Schematic Development Amendment SDPA-3-11 (REVISED):YBM Construction, Inc

Schematic Development Amendment SDPA-3-11 YBM Construction, Inc: Request to amend an approved Schematic Development Plan to reconfigure the location of building and parking facility, add to the height of the previously approved building, correct the size of the property and accommodate current environmental regulations and requirements for a property consisting of approximately 2.06 acres of land in the O-M Zone, located at 19815 Blunt Road in Germantown, Maryland.

SUBJECT: LATR for Schematic Development Plan Amendment No. SDPA-11-03
Plumgar Property
Germantown

Plumgar Property, Germantown
19815 Blunt Road
Amendment to Schematic Development Plan

ILLUSTRATIVE - BUILDING HEIGHT

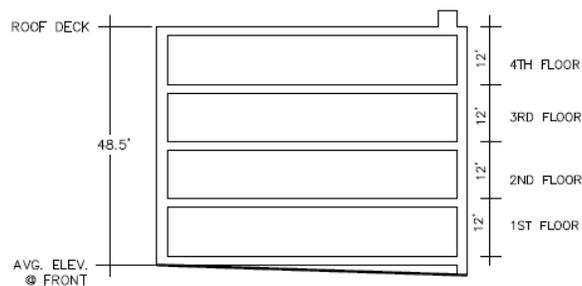
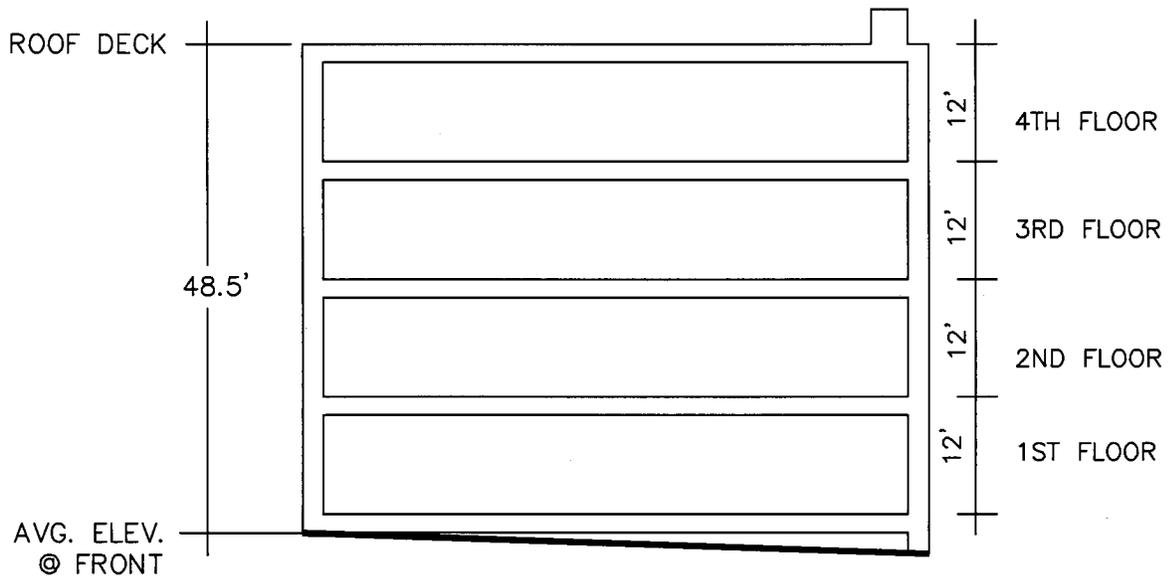
(1) *The Germantown Employment Area Sector Plan* was approved and adopted in 2009, nearly 20 years after the original reclassification of the site from R-60 Zone to the O-M Zone. The Plan confirmed the O-M zoning of the subject property with a specific recommendation for the subject area (Fox Chapel District) within which the property is located. Under the heading “Urban Form”, the Plan specifies that **“Building heights should not exceed 60 feet along MD 355, stepping down in height to 50 feet to 60 feet along the eastern edge of the district to be compatible with existing residential neighbors”**(page 75). The proposed height of 50 feet maximum/4-story conforms to the sector plan’s recommendation.

(2) The originally approved building includes a penthouse level which normally is not included in building height measurement but can

project a perception of a 4-story building. Moreover, the foot print of the proposed building is slightly lesser than that of the previously approved building. The current development plan provides for conservation easement and stream buffer that were not required at the time of the original approval of the plan 20 years ago. The proposed increase by one-story merely compensates for a building area that is dedicated for additional impervious areas.

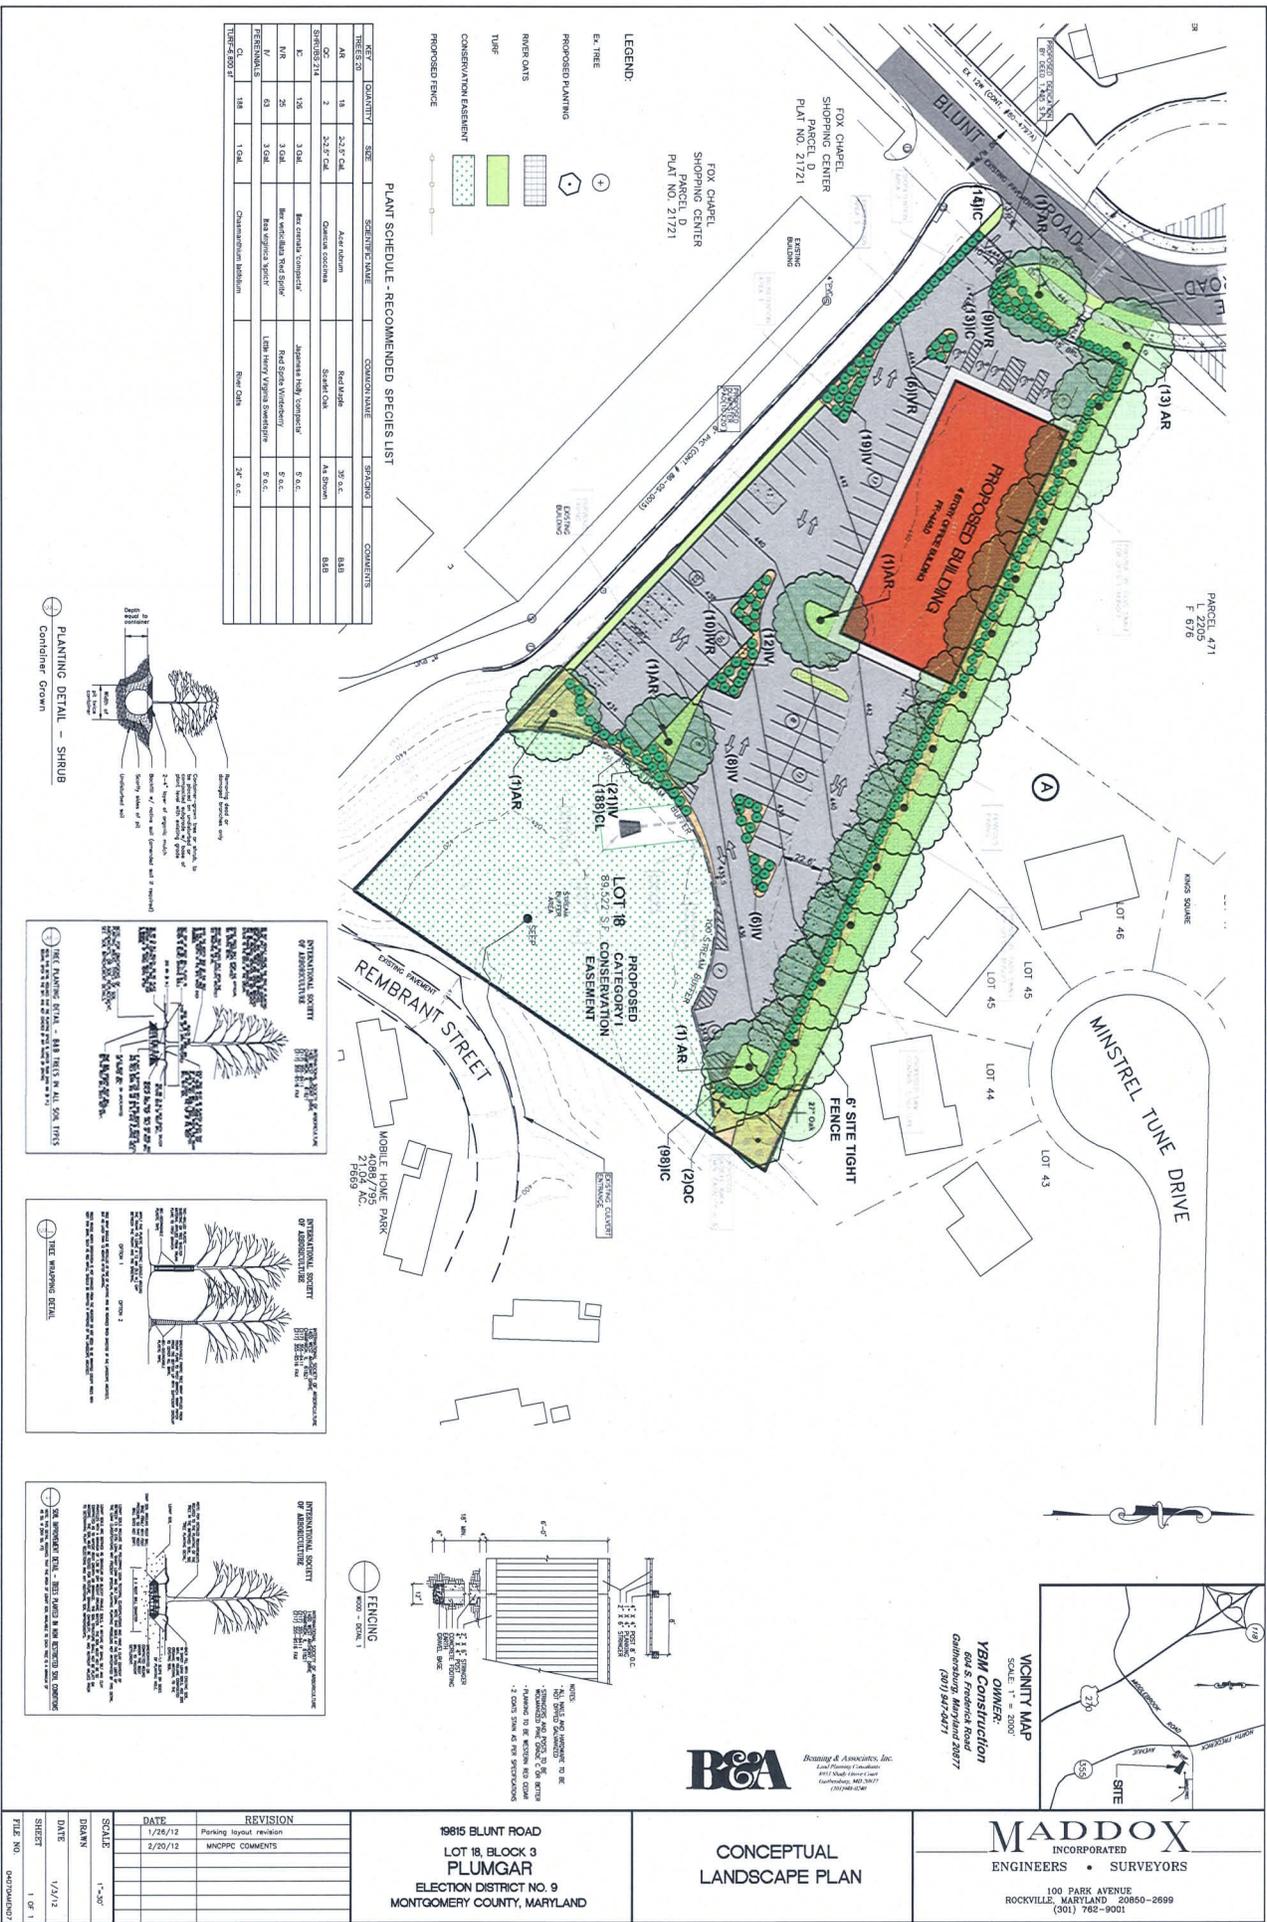
The proposed access points and internal vehicular circulation system shown on the development plan are safe, adequate and efficient. The Internal roads are proposed to be private roads. The number of parking spaces will support the proposed use, and meets the parking requirements. The applicant has responded to staff suggestions to make some changes to the originally proposed circulation pattern and overall parking facility design. Although, the revised plan

offers a somewhat improved circulation pattern, issues concerning the placement of the handicap parking places and the location of parking spaces within the front yard would need to be further explored. These issues as well as the final decision on the total required parking spaces will be addressed and determined at the time of Site Plan review.
